UNITED STATES
NUCLEAR REGULATORY COMMISSION
WASHINGTON, D.C. 20555-0001

SUBJECT: ACCOLADE FOR DR. GERRY L. STIREWALT, MANDEX'S TECHNICAL LEAD/SUPERVISOR IN CRADAL, FOR WORK PERFORMED IN SUPPORT OF THE NATIONAL PROGRAM FOR DISPOSAL OF HIGH-LEVEL RADIOACTIVE WASTE IN 1998

APPENDIX F

REVIEW OF U.S. DEPARTMENT OF ENERGY'S GEOLOGIC FRAMEWORK MODEL, VERSION 3.0 (GMF3.0)

Figure 9 - Cross section 2. See Figure 7 for location.

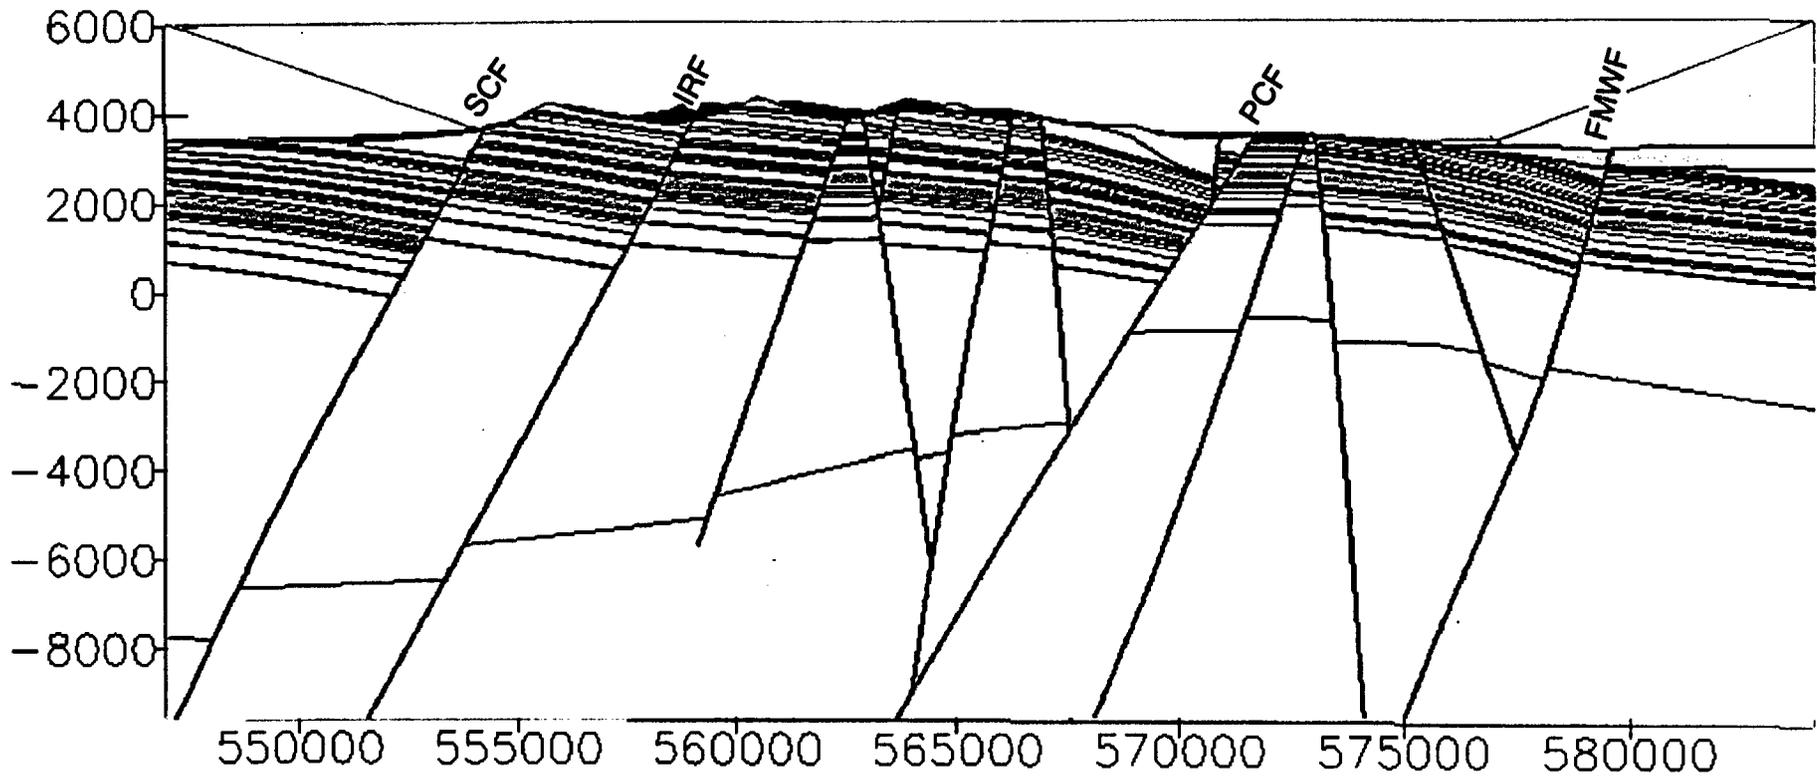
- g. Many faults are shown with displacements across the Paleozoic surface that are generally greater than the displacement of the base of the younger Trambt. The exceptions to this are the Solitario Canyon fault in Sections 2 (Figure 9), 3 (Figure 10), 4 (Figure 11), and 9 (Figure 16) and the Forty Mile Wash fault in Section 9 (Figure 16). Increasing differential displacement with depth implies growth in at least the earlier Tertiary sequence, so it may be helpful to clarify whether implied growth is part of the premise for GFM3.0. These displacements for the Solitario Canyon and Forty Mile Wash faults are at the northern and southern edges of the model where well control is

Figure 10 – Cross section 3 illustrates complex fault geometries, including fault displacement decreasing with depth (SCF), faults that are terminated updip by other faults, and crossing fault geometries. See Figure 7 for location.

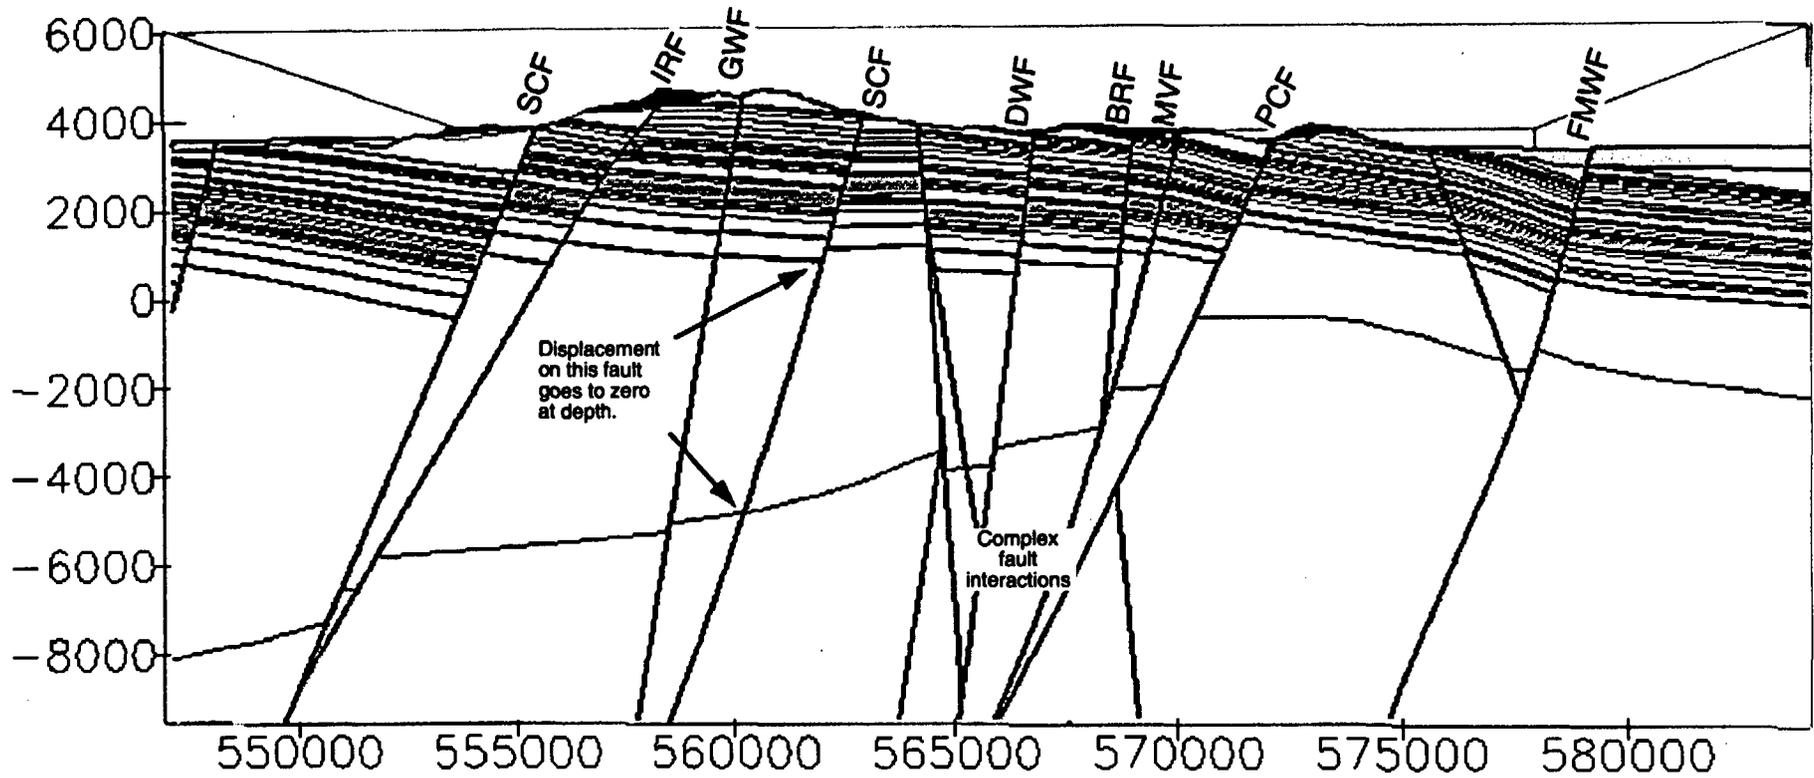
- h. Complex interactions between faults with opposing dip (e.g., Section 3, Figure 10) are likely in the Yucca Mountain area (Brocher, et al. 1998) and may be important influences on groundwater flow (Ferrill, et al. 1998). Variable displacement values between different units at the same position along a given fault and beheaded faults without a continuation across the offsetting fault are examples of complex fault interactions. Consider clarifying whether these complex interactions are real or modeling artifacts.

Figure 11 – Cross section 4. The DWF fault is continuous through model stratigraphy in cross section 4, and is discontinuous in cross section 5 (Figure 12). See Figure 7 for location.

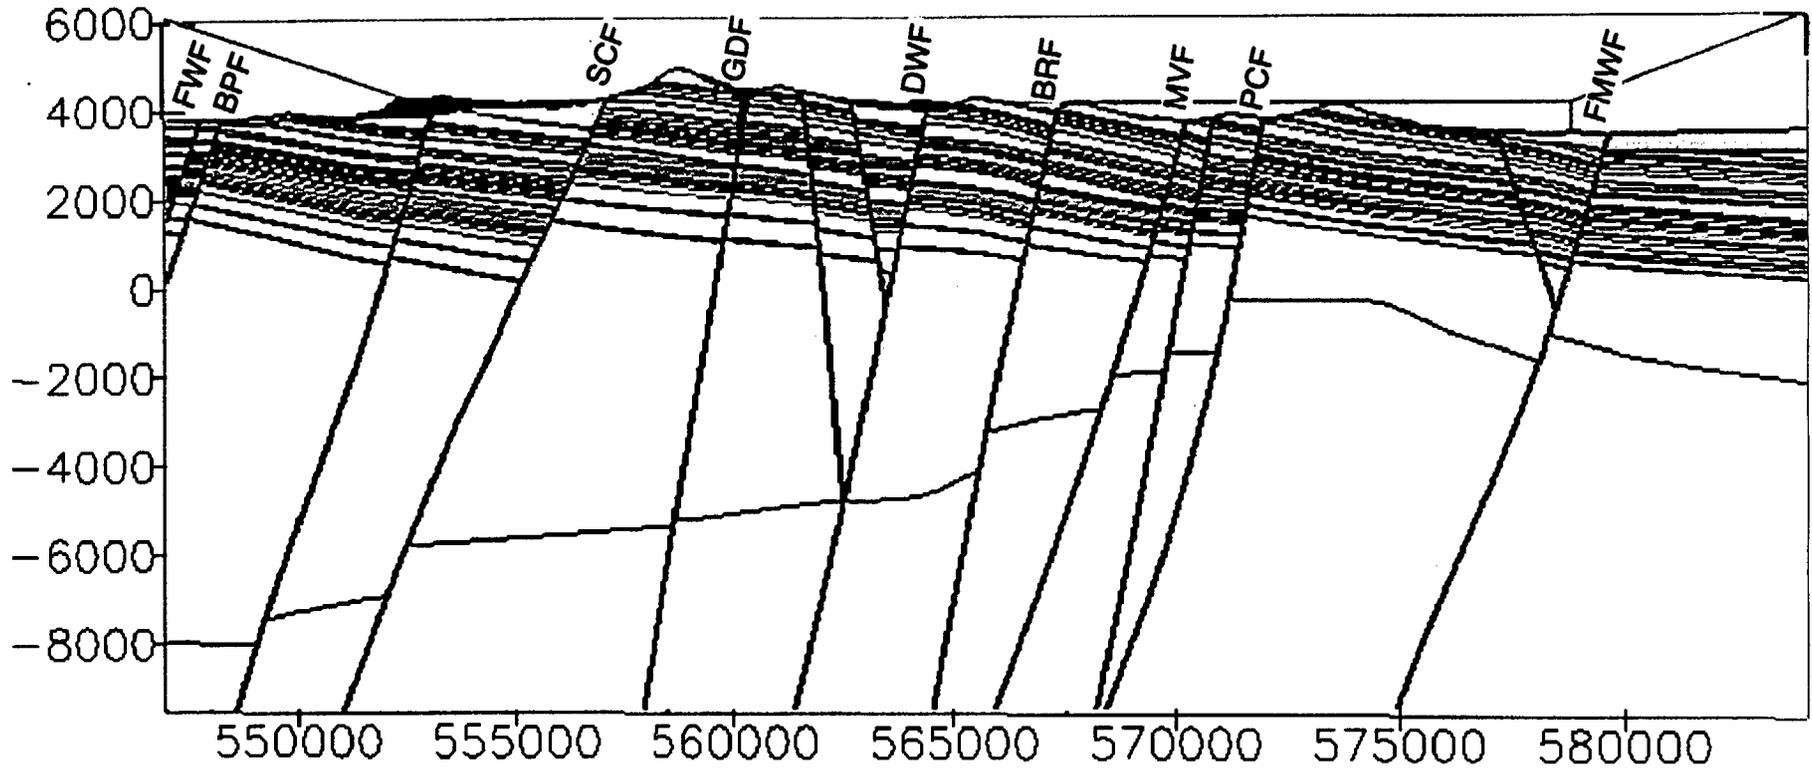
- f. The Dune Wash fault is shown to be truncated against the Ghost Dance fault in Section 5 (Figure 12) but not in Section 4 (Figure 11). This observation suggests a change in dip or "flexing" of the Dune Wash fault so some clarification may be useful.

Figure 12 – Cross section 5 illustrating truncation at depth of DWF fault by GDF fault and reverse of slip sense with depth of BPF fault (see also Figure 13). Section 4 (Figure 11) shows DWF fault continuous through model stratigraphy. See Figure 7 for location.

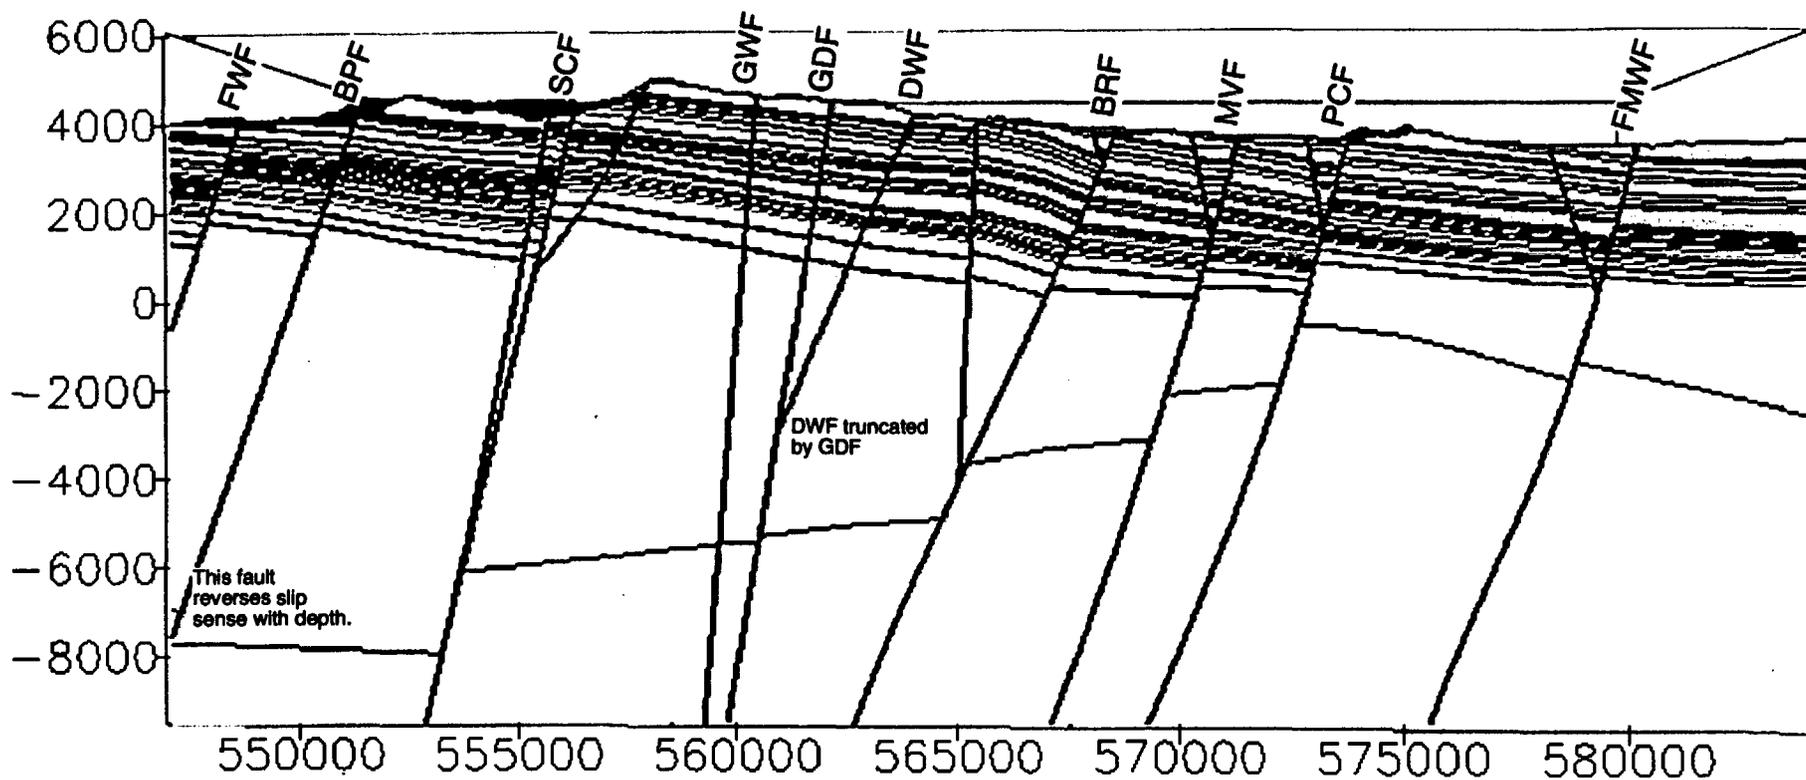
- e. The Boomerang Point fault is shown as reversing displacement at depth in Sections 5 (Figure 12) and 6 (Figure 13). This may be due to model construction artifacts or potential uncertainty on the depth to the Paleozoic surface, so clarification may be helpful.

Figure 15 - Cross section 8 illustrating folded beds in the hanging wall of FMWF without curvature of associated fault surface. See Figure 7 for location.

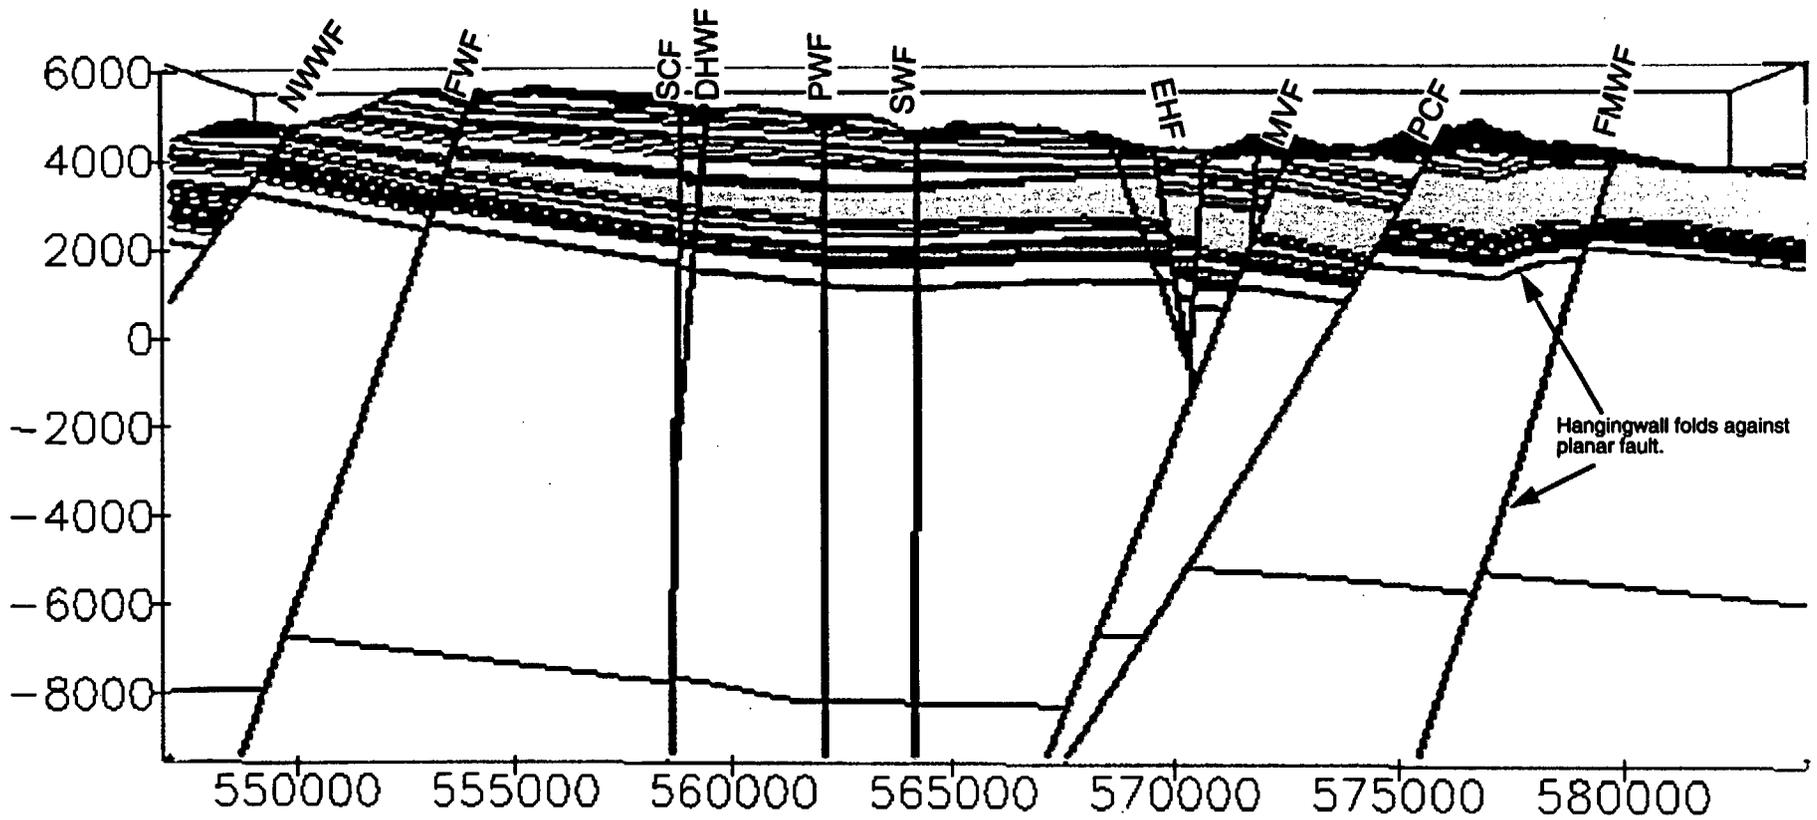
- d. Folding developed in the hangingwall blocks of faults is generally attributed to a curved (i.e., listric) fault geometry at depth (Suppe, 1983; Dula, 1992). Sections 1 (Figure 8) and 8 (Figure 15) through the model appear to illustrate folding of units in hangingwall blocks although GFM3.0 is constructed with essentially planar faults. Explanation of why these units appear to be folded may be helpful. By some interpretations (e.g., Young, et al., 1992), at the depth to which the model was constructed (i.e., 8,000 feet below sea level), the Forty Mile Wash, Paintbrush Canyon, Midway Valley, and Bow Ridge faults would show curved trajectories.
